Catawba Unit 2 Current Technical Specifications Marked Copy

Description of Proposed Changes and Technical Justification

Change to Technical Specification on Engineered Safety Features Actuation System Instrumentation

Table 3.3.2-1 (page 5 of 5) Engineered Safety Feature Actuation System Instrumentation

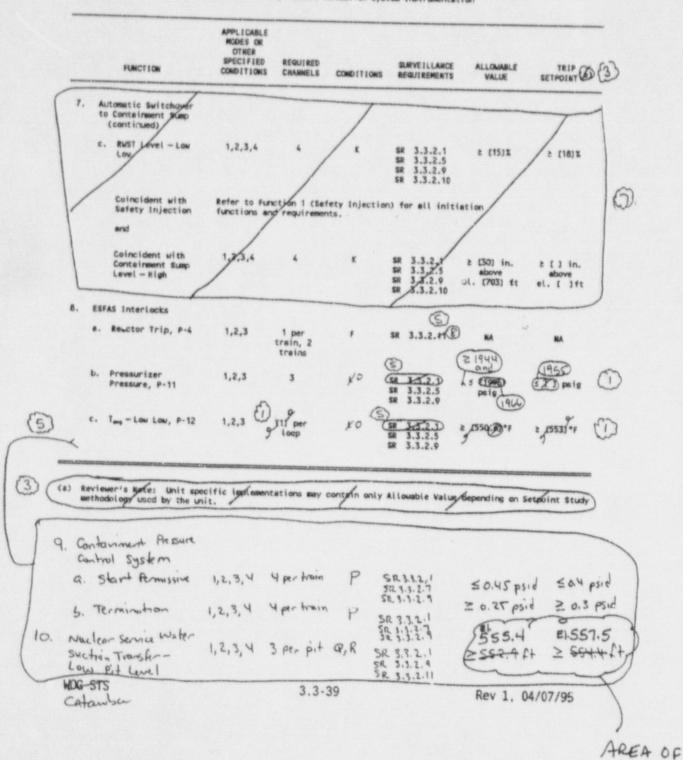
FUNCTION	APPLICABLE NODES OR OTHER SPECIFIED CONDITIONS	REQUIRED	CONDITIONS		RVEILLANCE	ALLOMABLE VALUE	TRIP SETPOINT
8.	ESFAS Interlocks							
	a. Reactor Trip, P-4	1,2,3	1 per train, 2 trains	r	SR	3.3.2.8	NA	NA
	 b. Pressurizer Pressure, P-11 	1,2,3	3	0	SR SR	3.3.2.5 3.3.2.9	2 1944 and s 1966 psig	1955 psig
	c. T _{avg} · Low Low, P-12	1,2,3	1 per Loop	0	SR SR	3.3.2.5 3.3.2.9	2 550°F	2 553°F
۹.	Containment Pressure Control System							
	a. Start Permissive	1,2,3,4	4 per train	Р	SR SR SR	3.3.2.1 3.3.2.7 3.3.2.9	s 0.45 psid	s 0.4 psid
	b. Termination	1,2,3,4	4 per train	Ρ	SR SR SR	3.3.2.1 3.3.2.7 3.3.2.9	2 0.25 psid	≥ 0.3 psid
D.	Nuclear Service Water Suction Transfer - Low Pit Level	1,2,3,6	3 per pit	Q,R	SR SR SR	3.3.2.1 3.3.2.9 3.3.2.11	2-552.9 ft EL555.4	2 554.4 ft

NUREG 1431 Technical Specifications Marked Copy and Catawba Nuclear Station Units 1 and 2 Current Technical Specifications Marked Copy Table 3.3.2-1 (page 8 of 8) Engineered Safety Feature Actuation System Instrumentation

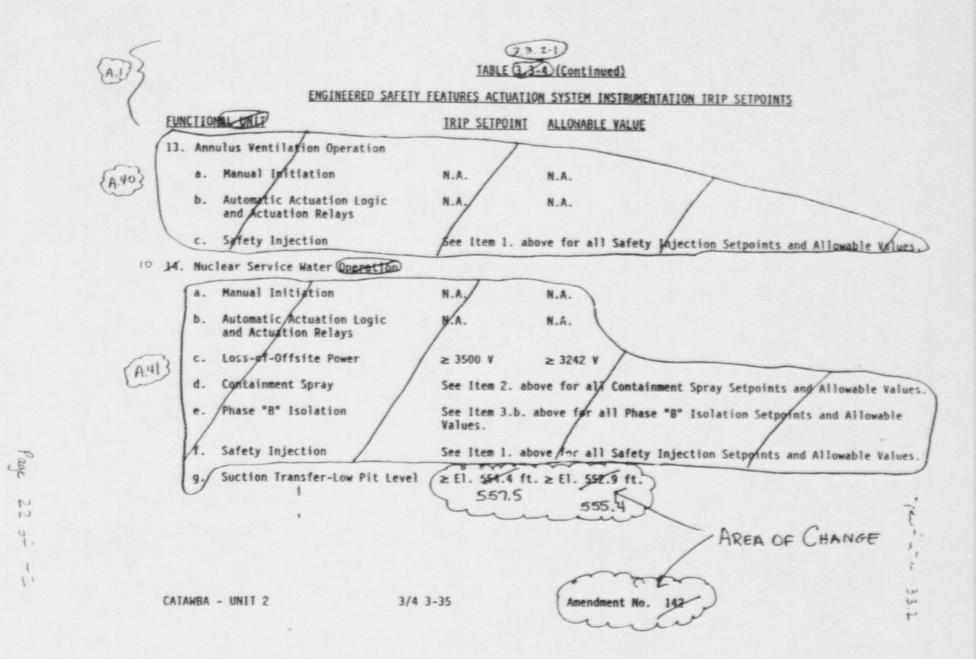
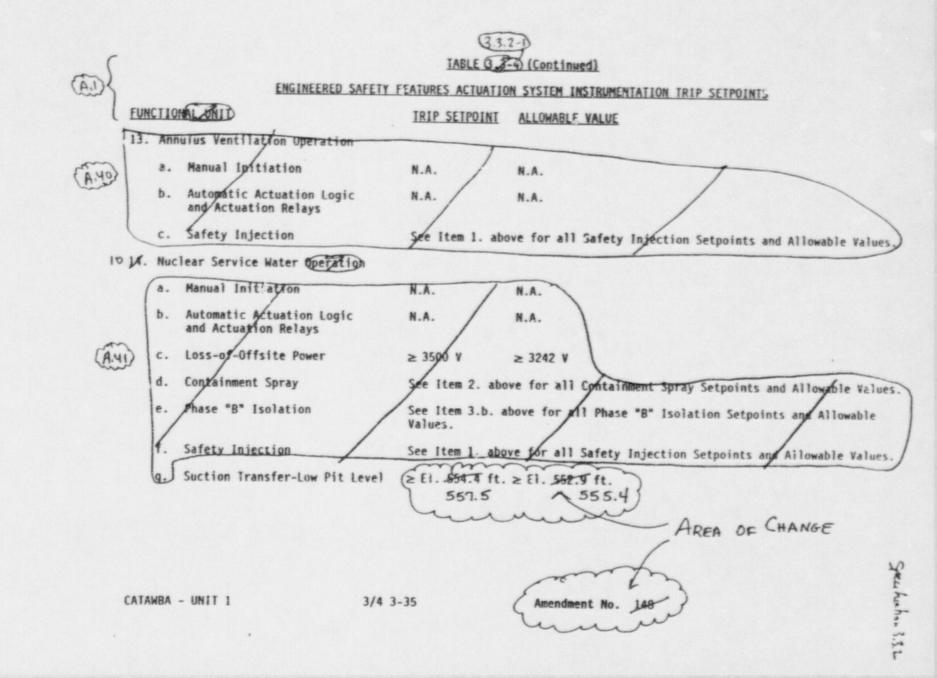
CHANGE
